# Memo

**Subject:** RCC 14-13: Timothy W. Condon, a request for approval of exterior alterations of an existing building located within the River Corridor, on the following property:

**Location:** 1 W. Concho Avenue, located at the southwest corner of the intersection of West Concho Avenue and South Chadbourne Street; more specifically San Angelo Addition, Block B, Lot 21 & N 49' 5 1/2" of the E 100' of Lot, in central San Angelo.

CHADBOURNE STREET ELEVATION  
 ANGRY CACTUS RESTAURANT & BAR  
 SCALE 3/16" = 1'-0"

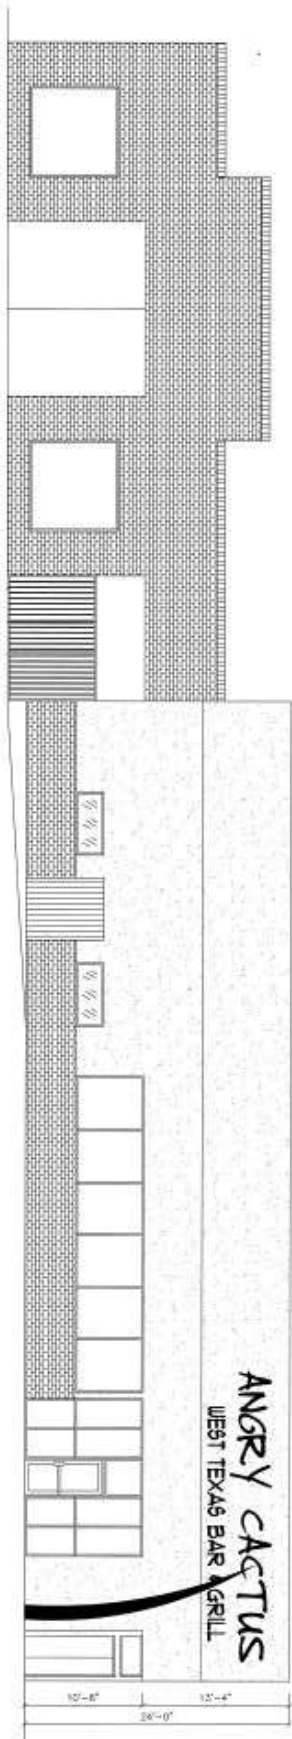
Staff would recommend that the applicant, however, provide more variations in building facades in accordance with 1.B.2. of the Master Plan “new buildings should reflect the characteristic rhythm of existing facades along the street (20-40 feet width)” and the *Historic Preservation Design Guidelines* which encourage “building wall offsets, including projections, recesses, changes in floor level, or changes of materials should be used to add architectural variety and interest, and to relieve the visual impact of a blank wall” and “the repetition of recessed entries provides a rhythm of shadows along the street, which establishes a sense of scale”. The Master Plan in Section 1.B.4 also encourages awnings and canopies as they “serve as a transition between the building,

While the applicant has done a good job providing varying materials and colors, including the brick at the bottom of the wall which will project out slightly, both walls are void of any columns or recessed entries. This gives the appearance of long, blank walls, especially along the longer wall facing Chadbourne Street, which is not consistent with other nearby properties. A review of the surrounding area shows other storefronts either have a canopy or recessed entry or both, providing variation in the building wall. Staff recommends that the applicant submit final plans prior to construction showing variation of the building's exterior facade which may include columns, recesses or canopies, to better blend within the area. Any canopies projected into a public right-of-way will require approval from City Council.

Staff also reviewed the proposed wall sign requests, the proposed cactus sculpture on the roof, and two large thorns attached to the bottom of the wall and which will overhang into the public right-of-way at the corner entrance.

The two attached walls signs will read "Angry Cactus West Texas Bar and Grill" and there will be one on the wall facing West Concho Avenue and one on the wall facing South Chadbourne Street. Each sign appears to be less than 25% of the wall area as required in 12.604 of the Sign Ordinance.

Permits Division has classified the proposed 15'-18' cactus at the top of the roof a "freestanding sign" and not an artistic sculpture because the cactus relates to the business and thus is not deemed art. The definition of a "sign" in the Sign Ordinance means:

The maximum height for a freestanding sign is 20 feet from the property line measured from the ground, and for every additional 2 feet in height, an additional setback of 1 foot is required to a maximum of 40 feet. The cactus will not encroach beyond the roof line. Because a freestanding sign is measured from the ground, it would include the 24 feet height of the building, plus the 15-18' height of the cactus for a total of approximately 39-42' in height, double the maximum permitted. Approval of this cactus sign would require a Sign Variance from the Planning Commission. Staff recommends that the proposed cactus be reduced in size to 10 feet to blend into the surrounding area and to avoid setting a precedent for large freestanding signs and structures in the River Corridor.

The applicant mentioned that the two large thorns at the front corner of the building will be attached to the wall at their bases, and gradually project out 1-2 feet at the top, about 20 feet from the ground. City Council approval will be required for any portion of the thorns that projects into the public right-of-way.

1. That the applicant submit final plans to be administratively approved by the Planning Director, prior to construction, showing the final color scheme and building materials, signage, lighting, and variation to the building walls with columns, recesses and/or canopies to be consistent with the existing character of the area. Any canopies projected into a public right-of-way will require approval from City Council;

4. If the proposed thorns encroach within the rights-of-way of the two adjacent streets in front of the building, it requires City Council approval.
5. Staff recommends attached wall signs where only the lettering is backlit rather than signs where the entire sign area, including areas outside the lettering is internally illuminated for overall consistency, and that the proposed signs shall not produce lighting that is excessively bright.
